Extended Power baseline proposal

v250

Replace Figure 33-18

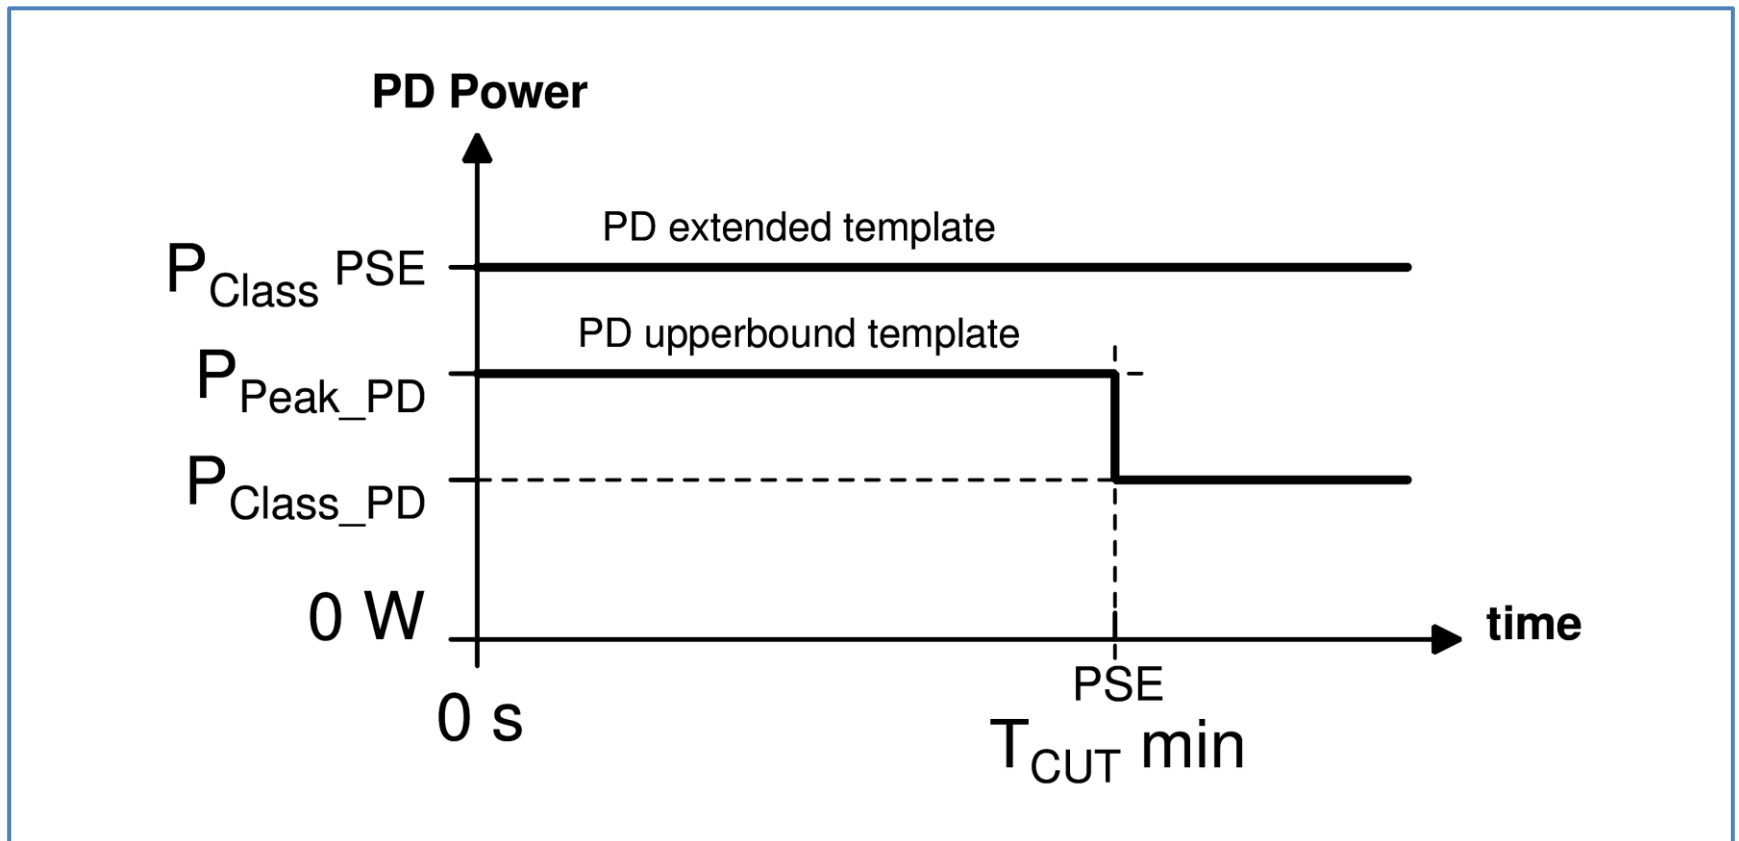
Under normal operating conditions when there are no transients applied at the PD PI, Type 3 and Type 4 PDs that observed 4 classification events and presented a Class 6, 7 or 8 signature, or observed 5 classification events and presented a Class 8 signature shall operate below the PD extended template defined in Figure 33-18. Type 1 and Type 2 PDs, Type 3 and Type 4 PDs in Class 5 or 7, or PDs that cannot guarantee that the PSE will source less than P_{Class} shall operate below the PD upperbound template defined in Figure 33-18.

Clarification: this text & figure do not allow the PD the exceed the upperbound template unconditionally. The condition is that the PSE shall not be caused to source more than P_{class} . This restriction is handled in section 33.3.7.2.

Add after description of $P_{PDUT}(t)$ in 33.3.7.5

The PD extended template in Figure 33-18, P_{PDET} , is described by Equation (33-xx):

$$P_{PDET}(t) = \{P_{Class} \text{ for } (0 \leq t)\}_w$$

t	is the duration in seconds that the PD sinks I_{port}
P_{Peak_PD}	is the peak operating power, $P_{peak_Pd}max$, as defined in Table 33-18
P_{Class_PD}	is the maximum power, $P_{class_Pd}max$, as defined in Table 33-18
P_{Class}	is the minimum power output by the PSE, as defined in Table 33-7 and section 33.2.6
